**Environmental
Planning
Commission**

**Agenda Number: 5
Project Number: 1006864
Case #: 13EPC-40143
November 14, 2013**

Staff Report

Agent	Consensus Planning, Inc.
Applicant	Pulte Group
Requests	Site Development Plan for Subdivision-Tract N-2-A and N-2-G (Portion)
Legal Description	Tract N-2-A and N-2-G (Portion)
Location	Watershed @ Estrella Subdivision, west of Tierra Pintada Blvd. and south and east of the Petroglyph National Monument
Size	Approximately 59.2 acres
Existing Zoning	SU-2 for PDA
Proposed Zoning	No Change

Figure 5: Example of failed rear yard walls at base of escarpment (Rockcross Court, Taylor Ranch)

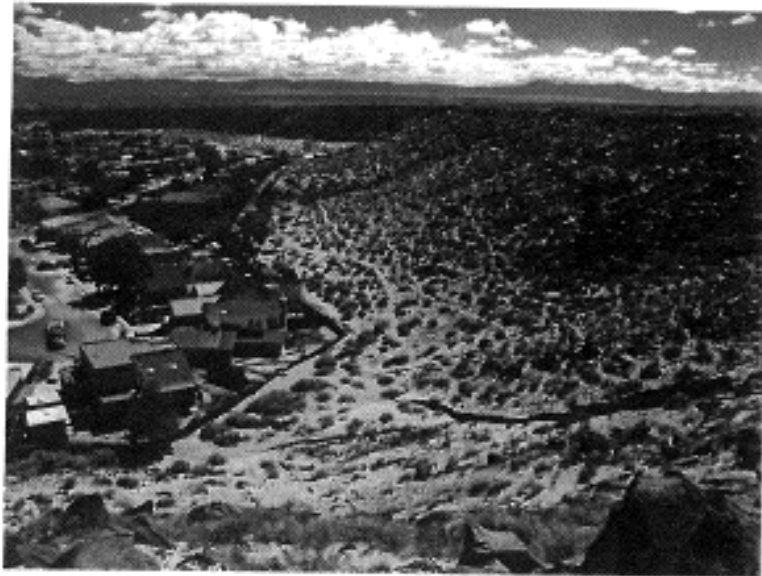
Recent erosion and sediment damage along many developed areas of the National Monument boundary demonstrate the need for careful planning and engineering to avoid similar results and property loss. Examples of recent erosion and flood damage onto single-loaded streets cut below existing grades are shown in the attached photographs (Figures 1 and 2). Examples of successful single-loaded street designs with minimal cuts into the existing topography are shown in the attached photos (Figures 9 and 10).
